Hearing Examiner Staff Report and Recommendation

Spring Hill

Preliminary Plat (P-Plat) and
Performance Based
Development (PBD)

Staff Report: 23-03018 Spring Hill PPLAT & 24-02627 Spring Hill PBD

Attachment A: Project Site Plan

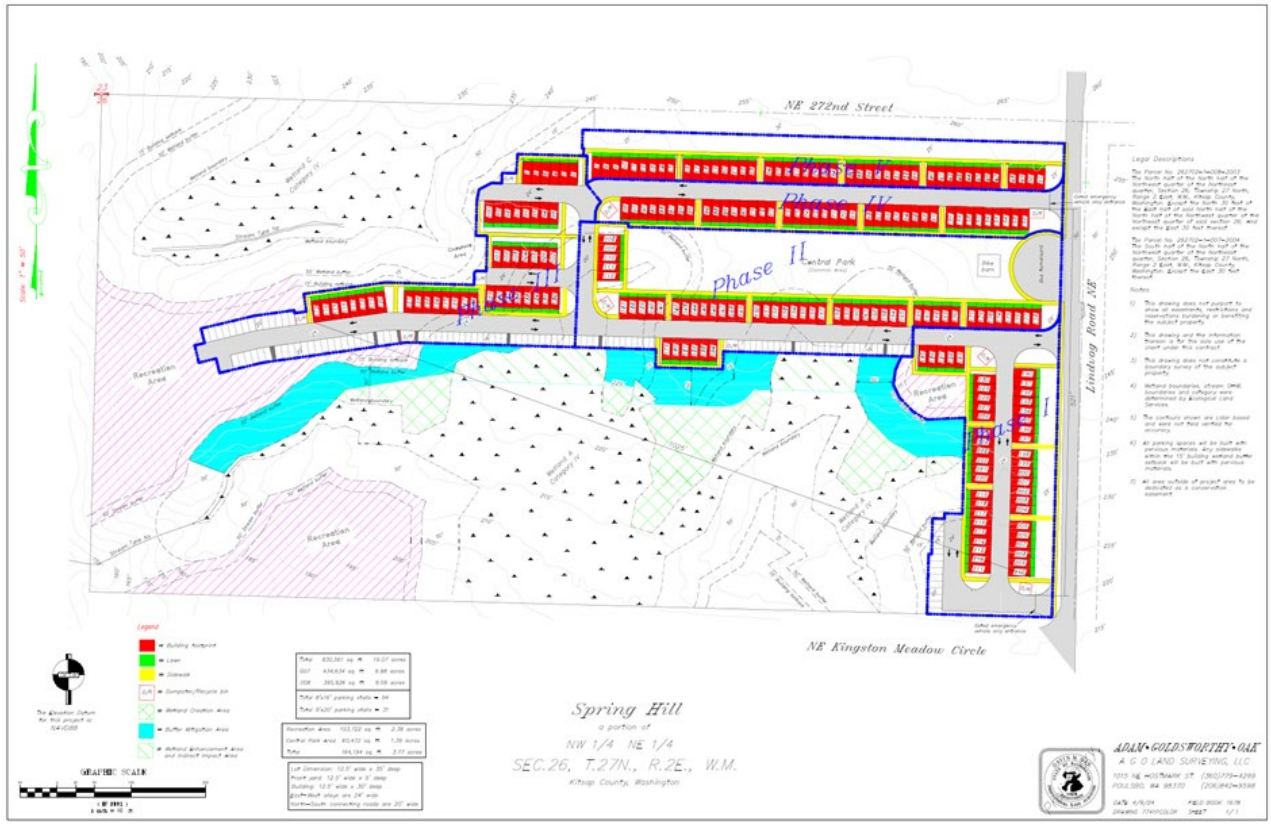
Staff Comment: A project may include wetlands to meet minimum lot dimensional and area requirements. However, each parcel must include a viable building site outside the buffer and building setbacks as prescribed by KCC. The project proposes parcels completed encumbered by wetlands which does not meet KCC.

Staff Comment: The Civil and Landscape plans, show trails in required critical area vegetation buffers, including wetlands. The trails primarily only traverse over these critical areas to reach viewing platforms outside of wetlands and their buffers. An exception to this is pedestrian circulation around structures located on wetlands or in the associated buffers.

The project does not provide an appropriately designed turn around for the westernmost portion of site. The road length of approximately 500 ft requires this turnaround designed with the 25 ft internal radius and sufficient room for emergency vehicle to maneuver.
